MONTGOMERY COUNTY PLANNING DEPARTMENT
THE MARYLAND-NATIONAL CAPITAL PARK AND PLANNING COMMISSION

MEMORANDUM

REVIEW TYPE: Preliminary Plan of Subdivision

PROJECT NAME: Finlandia
CASE #: 120080380
REVIEW BASIS: Chapter 50, Montgomery County Subdivision Regulations

Attachment B – Proposed Plan

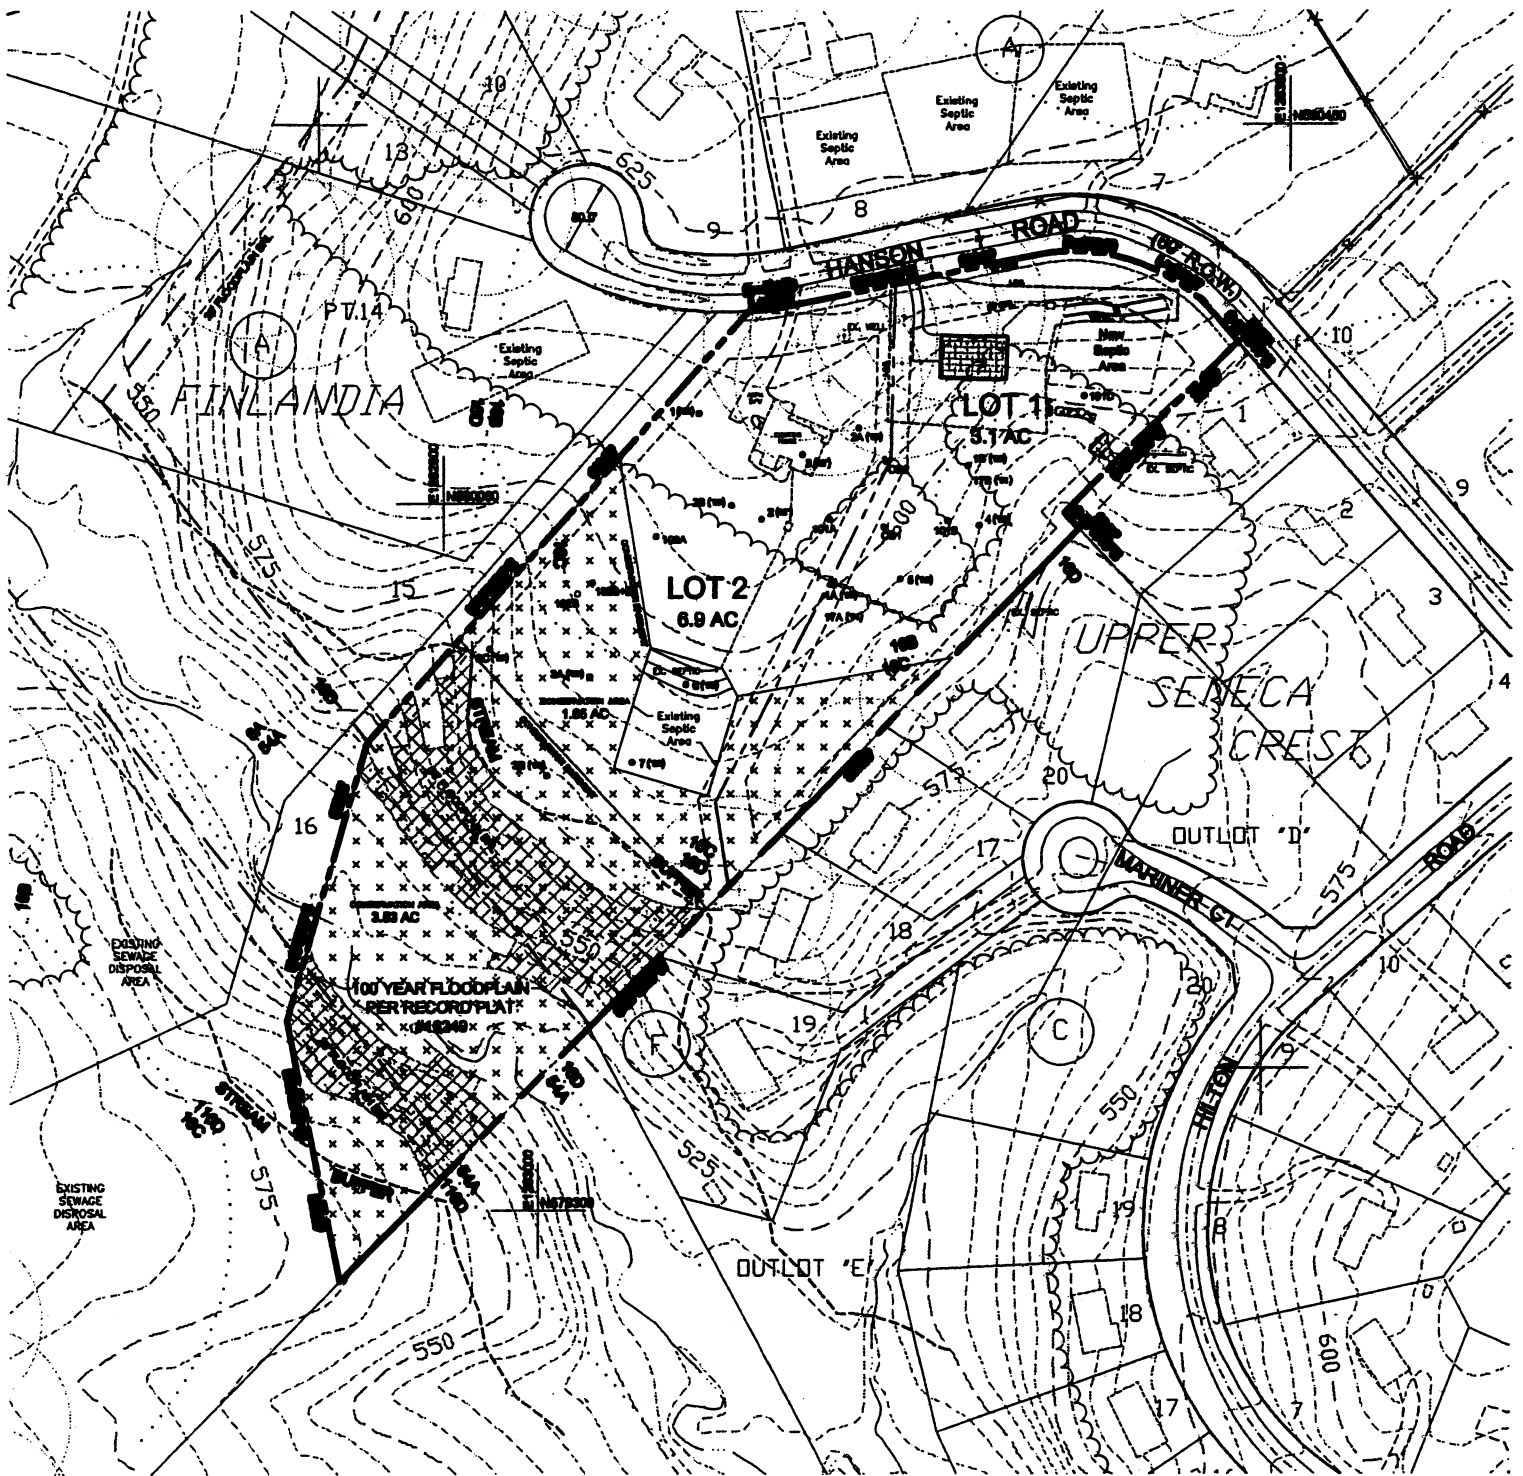
We have completed our review of the preliminary plan dated 04/07/08. This plan was reviewed by the Development Review Committee at its meeting on July 14, 2008. We recommend approval of the plan subject to the following comments:

1. Show/label all existing planimetric and topographic details specifically storm drainage and driveways adjacent the site on the preliminary plan.
2. Right of way dedication for Hanson Road as necessary.

3. ~~Grant necessary slope and drainage easements.~~ Slope easements are to be determined by study or set at the building restriction line.
4. Wells and septic systems cannot be located within the right of way nor slope or drainage easements.

6. Revise the plan as necessary to meet the requirements of the Montgomery County Department of Permitting Services with regard to wells and/or septic systems.
